Detailed Comments of Pilkington North America, Inc.

The Department of Energy's (DOE) 11 February 2003 letter and attachments (Letter) offers two alternative proposals for review and comment. The first alternative is "the same one proposed in May 2002, based on a three-zone map." The second is based on a four-zone map. The DOE Letter indicates that both alternatives "meet our objectives of increasing energy savings, meeting or exceeding code requirements, and offering a consumer-friendly approach to selecting high-performance windows."

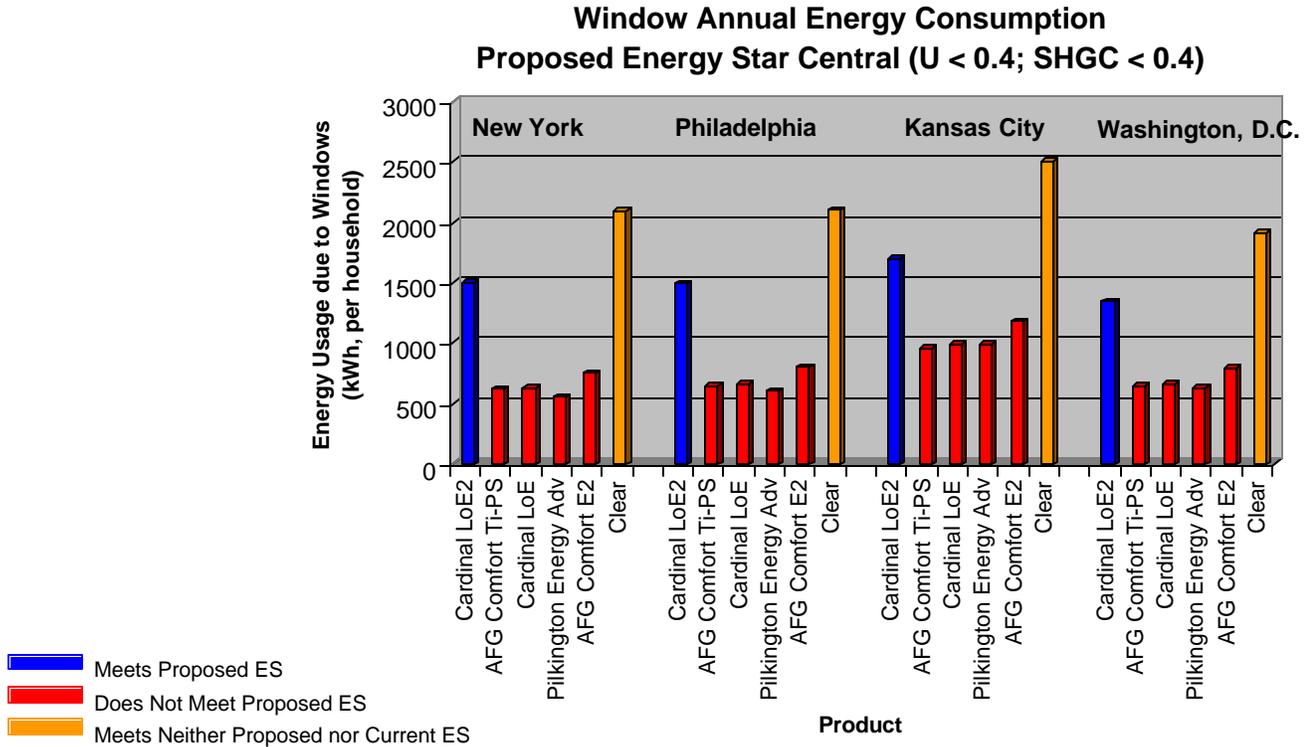
The following chart illustrates this point:

If the three-zone map is adopted, the *most energy efficient* subset of products listed above will *not* qualify for the Energy Star label while the *least efficient product* will qualify for the Energy Star label.⁹

This result would not only contradict the most important, stated objective of the Energy Star Program, it would mislead consumers. By selecting windows labeled under the three-zone criteria, consumers will actually be misled to select products that are *less*

⁹ The above chart compares the annual energy consumption (heating + cooling) impact of various types of glazing in a typical home in different cities in the Central region of the three-zone map. Vinyl framed, argon-filled double glazed windows were used, where only the type of glazing was varied. Calculations were done in accordance with NFRC 901 proposed guidelines using RESFEN 3.1 software based upon the U.S. Department of Energy calculation method (DOE 2.1E). The window properties, including angular dependence data, were calculated with Window 4.1 and imported into the RESFEN 3.1 program. To determine the individual impact of each glazing type on the home's annual energy consumption (heating + cooling), the energy usage of the home without windows was subtracted from energy usage of the home with windows for each of the window types described for each of the cities listed in the chart. Positive values for this difference represent the relative increase in home energy consumption contributed by the windows with the various types of glazing products and the best energy performance is represented by the products with the lowest value bars.
